# PD 1198

<b>10/15/2020 Minor Change/Site Plan</b> .....	<b>2</b>
Exhibits .....	4
<b>02/29/2016 Site Plan</b> .....	<b>11</b>
Exhibits .....	13
<b>02/23/2016 Minor Change</b> .....	<b>20</b>
Exhibits .....	21
<b>10/03/2014 Minor Change</b> .....	<b>23</b>
Exhibits .....	25
<b>07/25/2012 PD Adoption</b> .....	<b>28</b>
Ordinance .....	28
Statements .....	29
Bulk Table .....	34
Exhibits .....	35

Re: Minor Change and Site Plan Review for a new Starbucks store  
PD No. 1198, Subarea 2 - Outlot E, 4200 S. Pulaski Road

**1 PROPOSED SITE PLAN**  
 SP1.0 SCALE: 1" = 10'

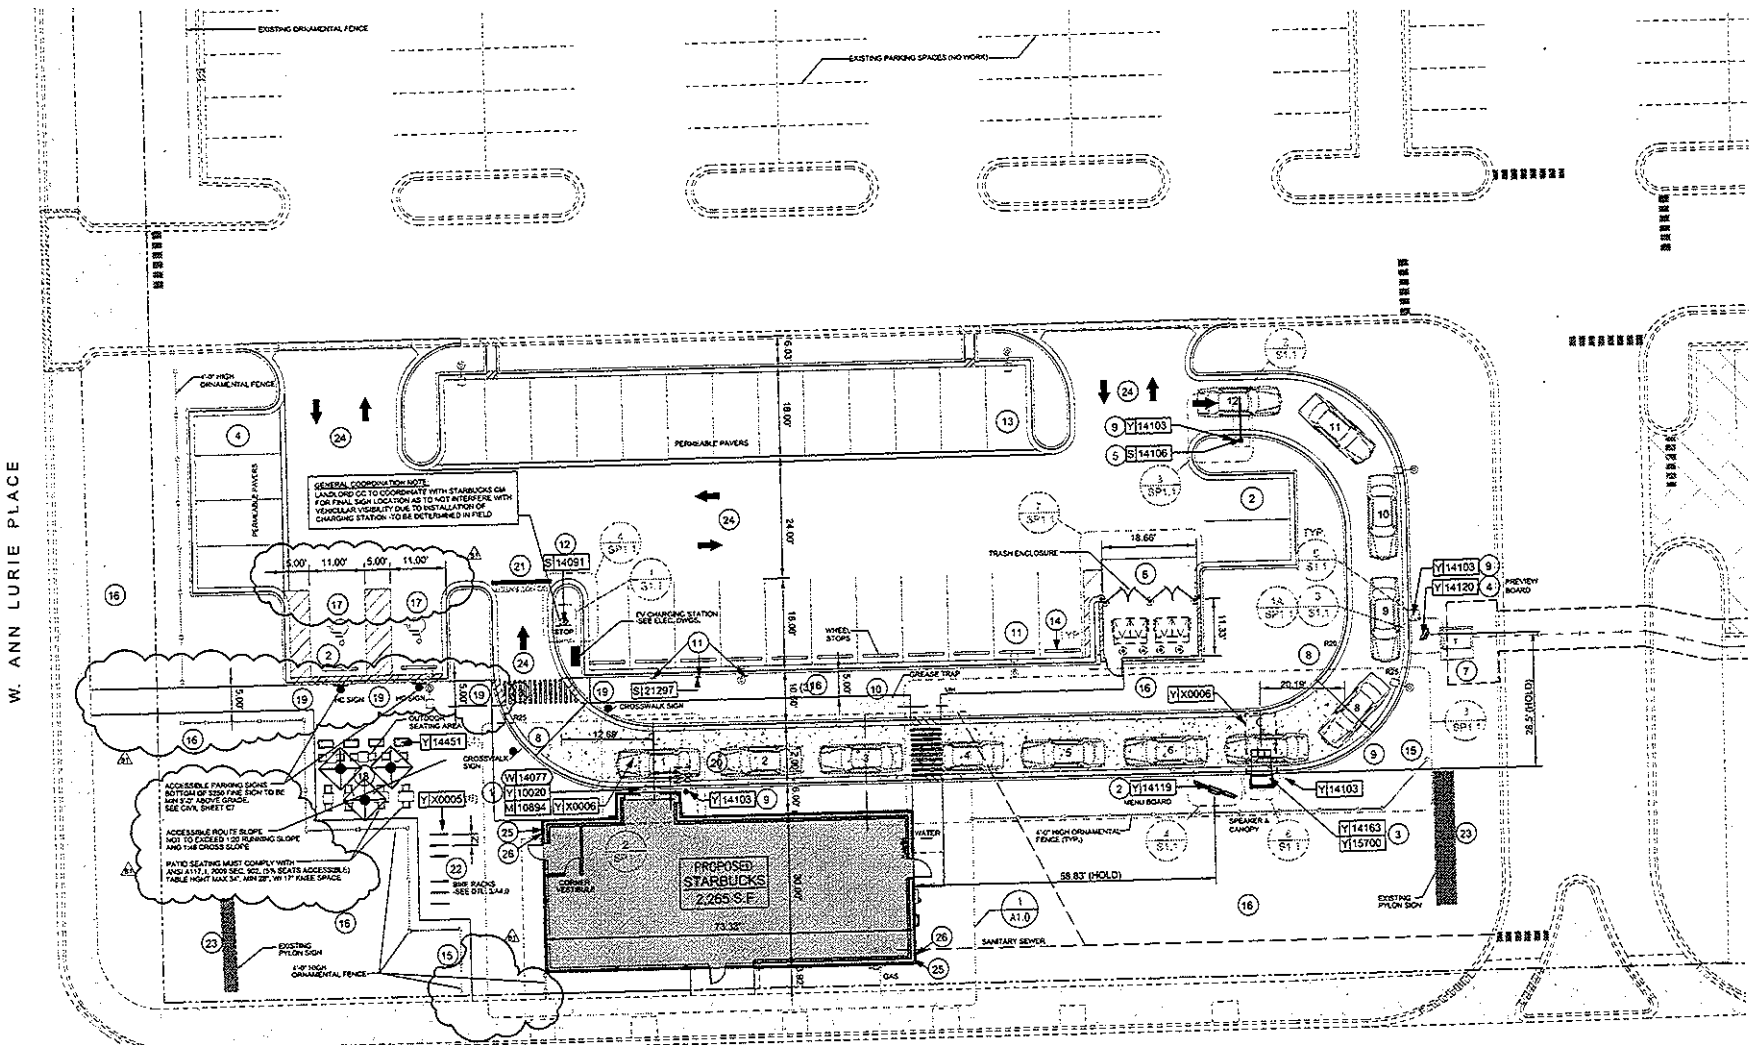
On behalf of the owner of Sub-area 2, Pulaski Promenade, LLC, you are requesting a minor change to replace the 100% green roof required in Statement No. 14 with permeable pavers. With regard to this request, the Department of Planning and Development has determined that allowing the permeable pavers, as shown on the attached site plan, will not create an adverse impact on the Planned Development or surrounding neighborhood, will not result in an increase in the bulk or density, and will not change the character of the development, and therefore, would constitute a minor change.

In regards to your request for site plan review, we have reviewed the attached plans and elevation drawings prepared by PFDA Architects, which were received on September 22, 2020. The proposed plans call for the construction of a 2,265 SF, one-story retail building with a drive-through facility. The scope of the project also includes providing new landscaping, an outdoor patio, new bike racks, a parking lot and new utilities. The new Starbucks store will occupy an outparcel that is 0.753 acres, and will provide 32 automobile parking spaces and 12 bike parking spaces. Other site improvements include new sidewalks and permeable pavers provided throughout the site.

Upon review of the material submitted, the Department of Planning and Development has determined that these plans satisfy the requirements of the Plan of Development, and are also in compliance with the City of Chicago's Sustainable Development Policy. In addition, the proposed plans have been submitted, reviewed and approved by the Mayor's Office of People with Disabilities, the Department of Transportation, the Fire Department, and the Department of Water Management. Accordingly, these plans are hereby approved as conforming to the Plan of Development as passed by the Chicago City Council and subsequently published in the City Council Journal on July 25, 2012.
